ITEM: 6.2	COMMITTEE OF ADJUSTMENT REPORT SUMMARY MINOR VARIANCE APPLICATION FILE NUMBER A021/23 22 CROWN CRESCENT, WOODBRIDGE
------------------	--

**COMMITTEE OF ADJUSTMENT REPORT
MINOR VARIANCE APPLICATION
A021/23
22 CROWN CR, WOODBRIDGE**

ITEM NUMBER: 6.2	CITY WARD #: 2
APPLICANT:	Diana Alvarado & Ramon Alvarado
AGENT:	Twain Warren
PROPERTY:	22 Crown Crescent, Woodbridge
ZONING DESIGNATION:	See below.
VAUGHAN OFFICIAL PLAN (2010) DESIGNATION:	Vaughan Official Plan 2010 ('VOP 2010'): "Low-Rise Residential"
RELATED DEVELOPMENT APPLICATIONS:	None
PURPOSE OF APPLICATION:	Relief from the Zoning By-law is being requested to permit a proposed swimming pool and an existing shed.

22 Crown Crescent Woodbridge, ON L4H 1S5			
client:		date:	revision:
scale:	1:125	2023-09-12	5
drawn by:	R.T	checked by:	R.T
		drawing #:	GRA - 1

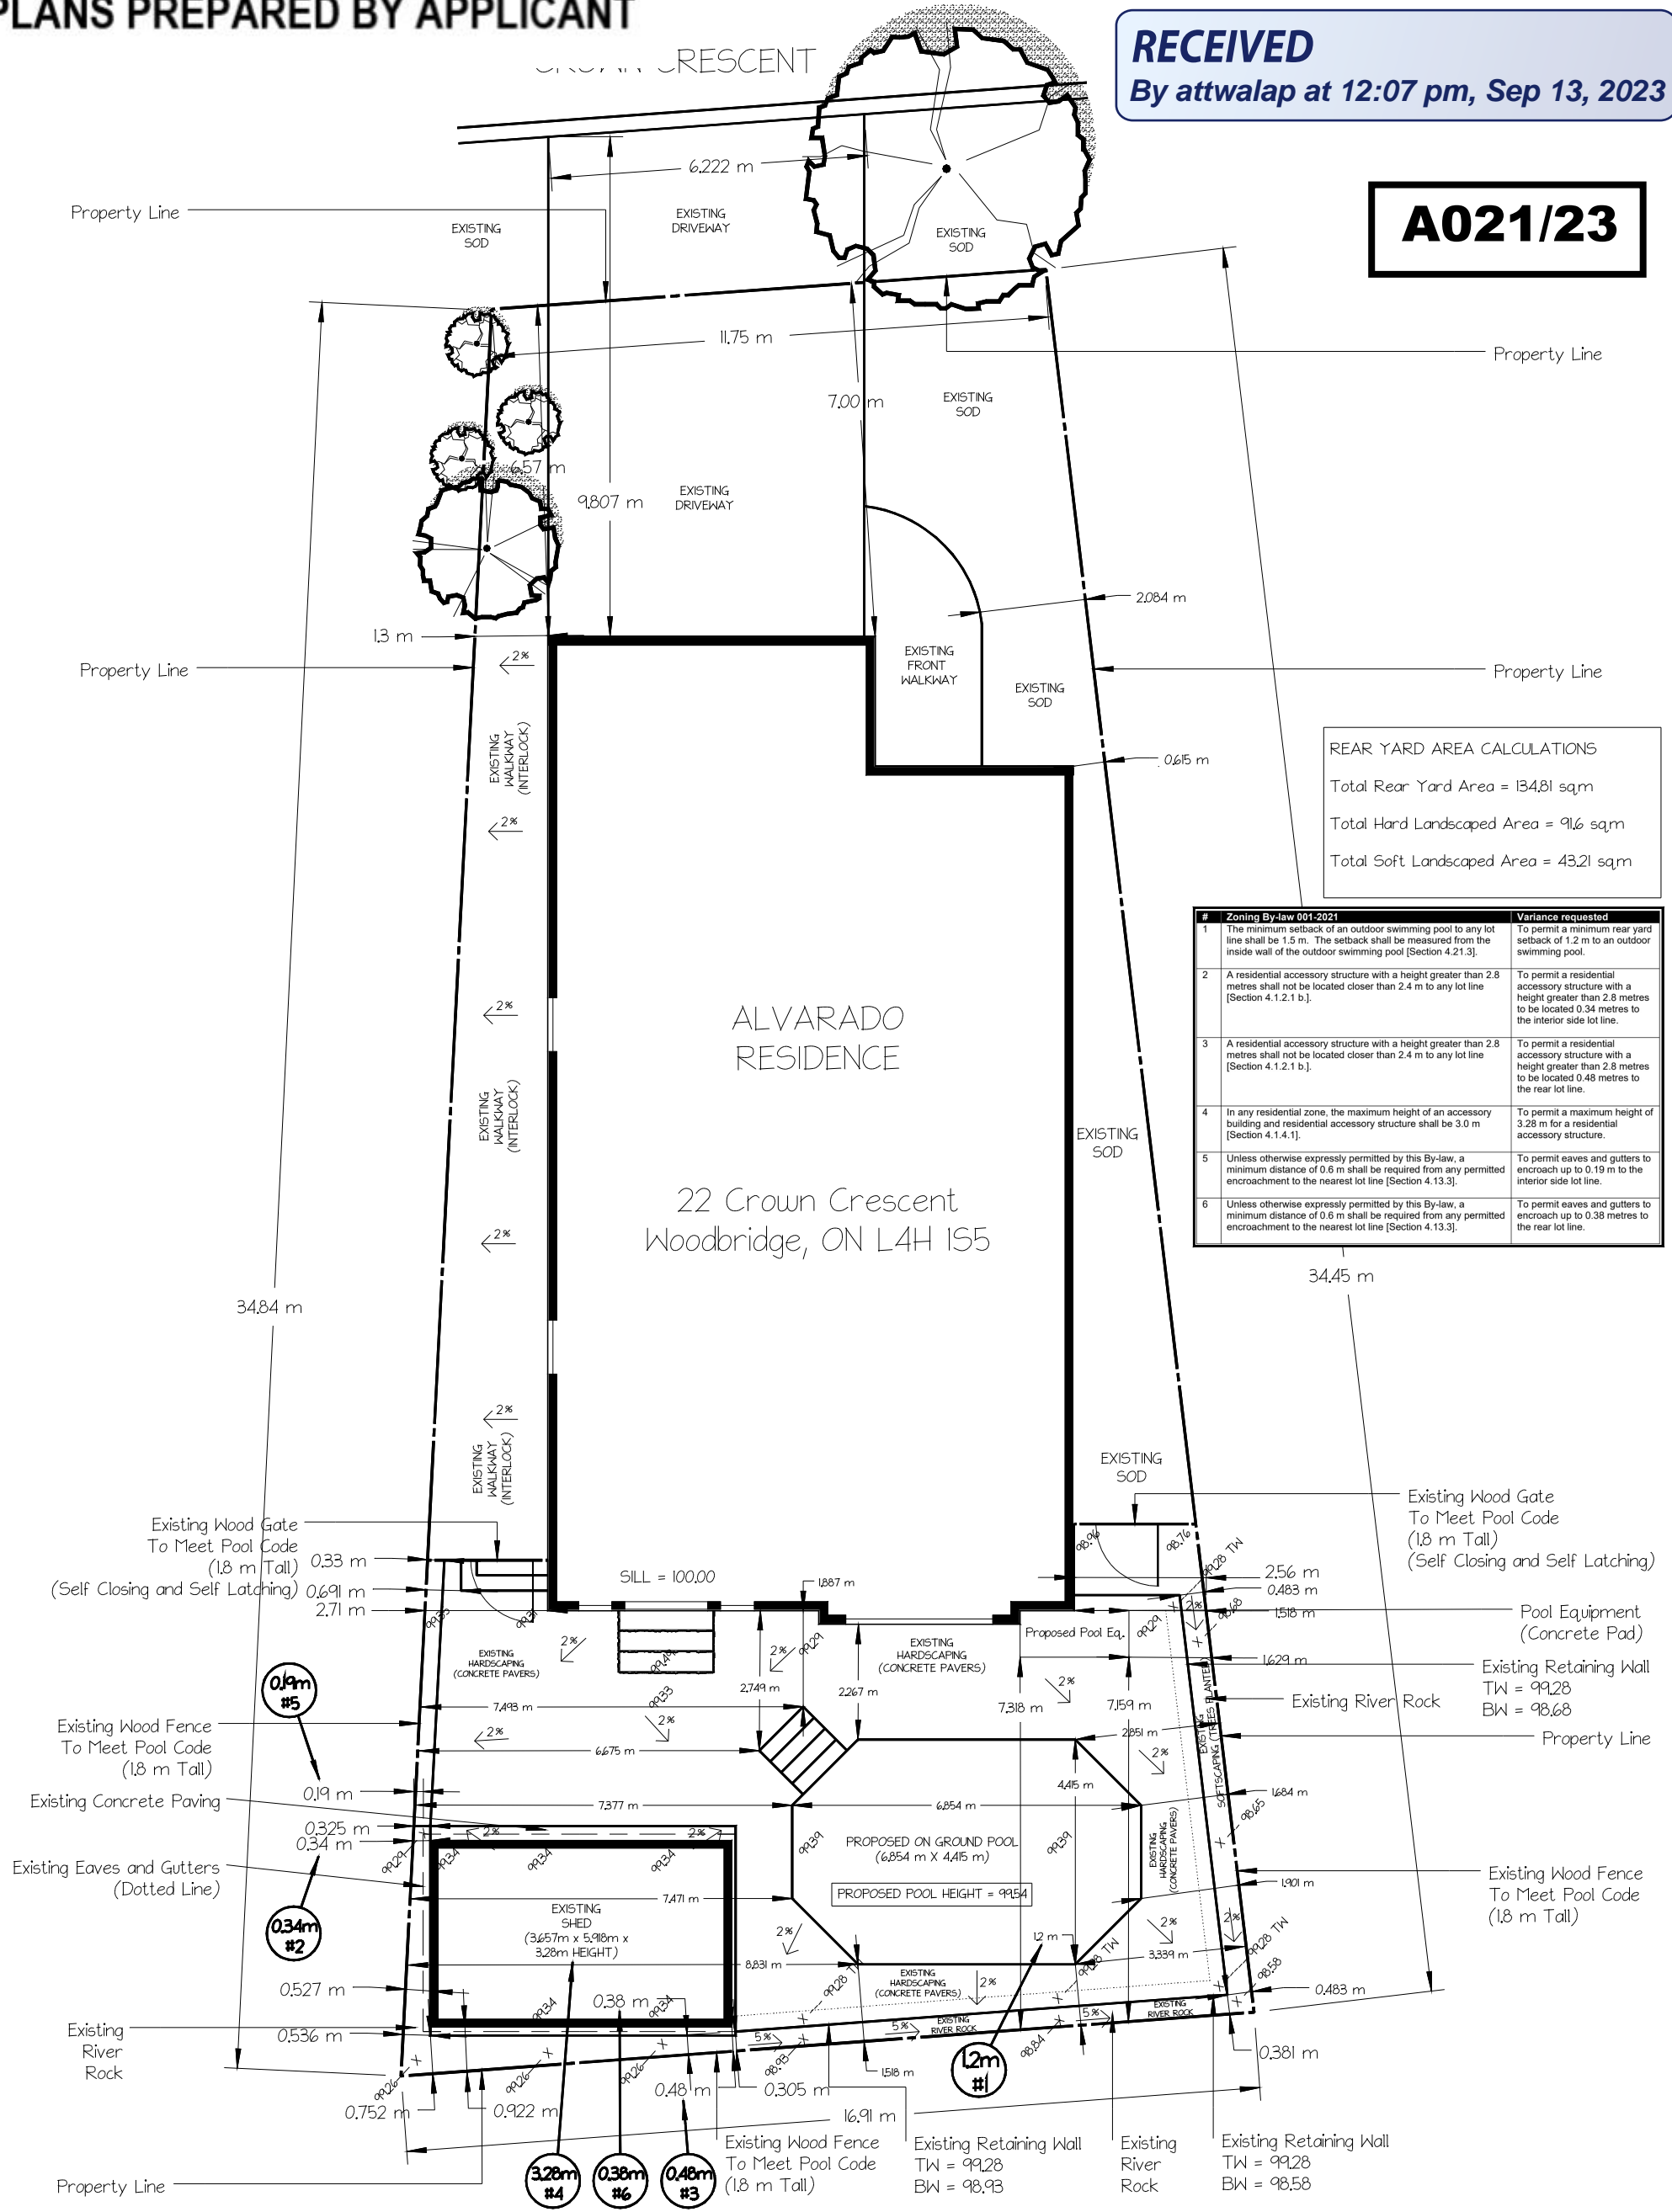
Due to the size of the proposed cabana on the subject property, which measures 21.64 m², the Owner/Applicant must acquire a Lot Grading Permit from the Development Inspection and Lot Grading Division of the City's Development Engineering Department. It's important note that any in-ground structure exceeding 10 m² necessitates a Grading Permit. Once the Grading Permit is obtained, please reach out to the Development Engineering Reviewer to clear the Condition imposed on this application.

The Owner/Applicant's proposed work involves increasing the Lot Coverage on the subject property. This addition of hardscape could potentially affect the City's Storm Water management system. Development Engineering highly recommends that the Owner/Applicant incorporate Low-Impact Development (LID) measures, such as bioswales, permeable pavers, rain gardens, rain barrels, etc., to minimize the impact on the stormwater system. If additional information is needed, please reach out to the Development Engineering COA reviewer.

The Development Planning Department has no objection to Variance 1 for the pool as the reduction to the rear yard setback is minor in nature, will only be fully utilized by a corner of the pool due to the angled rear lot line, and is not anticipated to be perceptible. The pool also complies with the interior side yard setback requirements in the Zoning By-law and maintains an appropriate area for safe access and maintenance.

Development Engineering Recommended Conditions of Approval:	The Owner/Applicant shall submit the final Lot Grading and/or Servicing Plan to the Development Inspection and Lot Grading Division within the City's Development Engineering Department before initiating any work on the property. To apply for a Grading Permit, please visit the Permit page on the City of Vaughan website. For any inquiries regarding the Grading Permit, please feel free to contact the Development Engineering Department via email at DEPermits@vaughan.ca .
--	---

Backyard Shed Dimensions

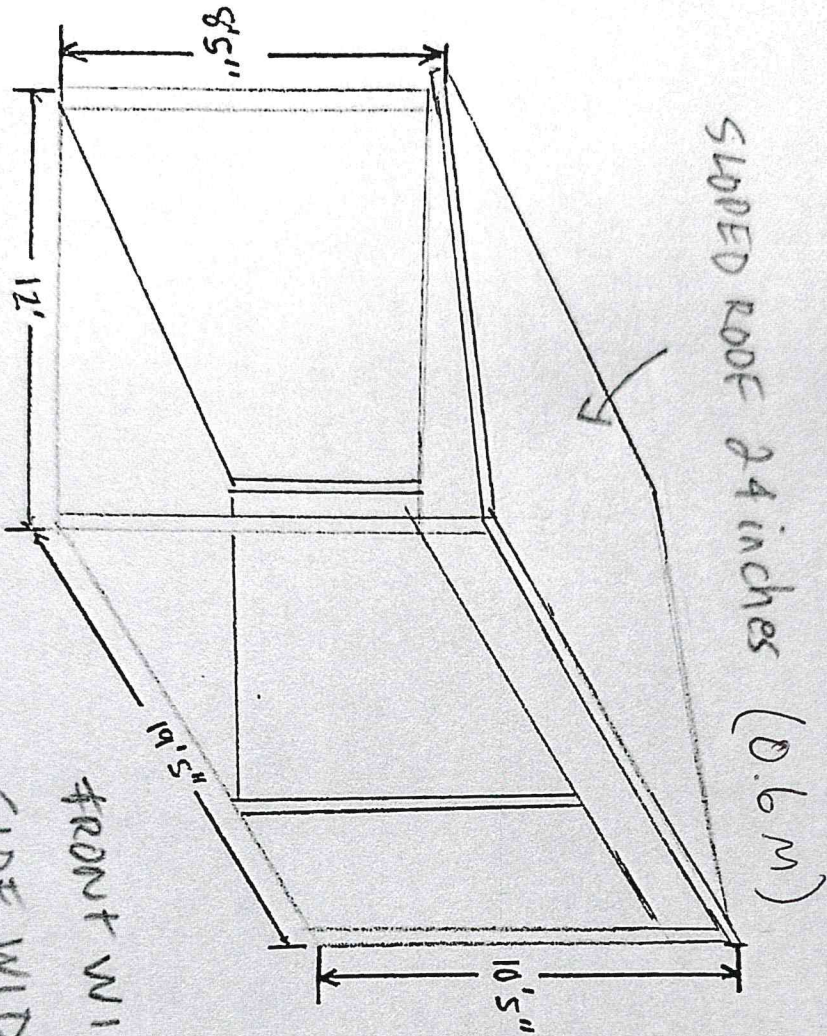
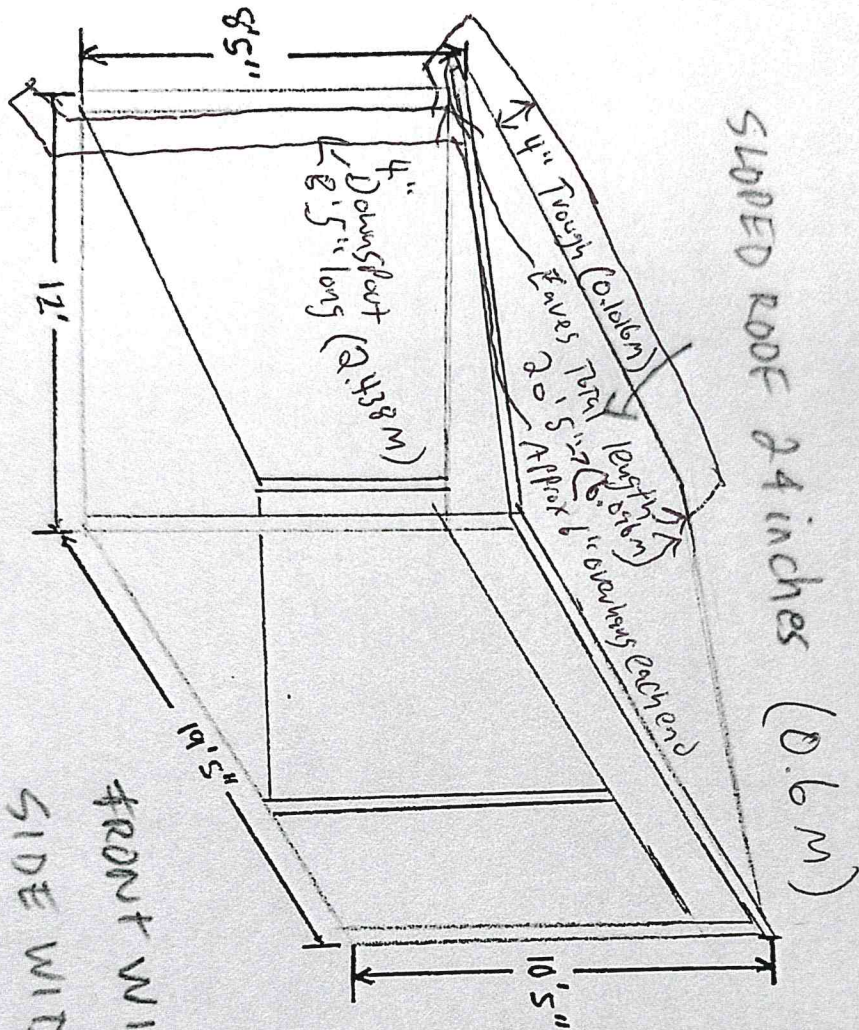
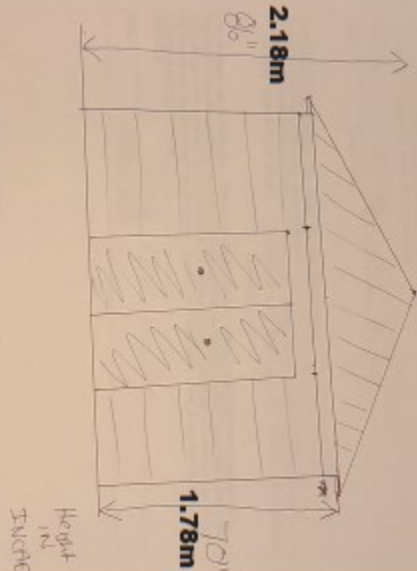
General Comments	
1	The applicant shall be advised that additional variances may be required upon review of detailed drawing for building permit/site plan approval.
2	The height of the residential accessory structure shall be measured in accordance with the definitions in section 3.0 DEFINITIONS of By-Law 001-2021 as amended. Established grade shall be the approved grading at the time of the original building permit for the principal dwelling.

The Development Planning Department has no objection to Variances 2, 3, and 4 for the residential accessory structure. The structure is modest in footprint and has a slanted roof that is lowest along the western side, facing the rear lot line. The proposed 3.28 m height is measured from the established grade to the highest roof edge, which faces the interior of the lot. The height of the structure when measured from the shorter roof edge is approximately 2.68 m. This results in a lower wall face fronting the neighbouring property to the rear, further mitigating the mass of the structure. Due to its modest footprint and the slanted roof design, the reduced interior side and rear yard setbacks are not anticipated to have adverse impacts to the neighbouring properties. The interior side and rear yard setbacks are also measured at pinch points and expand to 0.54 m and 0.75 m respectively, at their greatest extent. The Development Engineering Department has also reviewed the proposal and is satisfied that drainage in the rear yard will be maintained. As such, the structure is not anticipated to pose adverse use or

The Development Planning Department has no objection to Variances 5 and 6 for the encroachment of the eaves and gutters. The setback for the eaves to the interior side lot line is not anticipated to pose adverse massing impacts due to the modest size of the shed and the encroachment being measured at the pinch point between the interior side lot line and the structure. The setback for the gutter to the rear lot line is also measured to the pinch point between the rear lot line and structure. As such, the increase to the eaves and gutter encroachments are minor in nature and no adverse massing impacts are anticipated to the neighbouring properties.
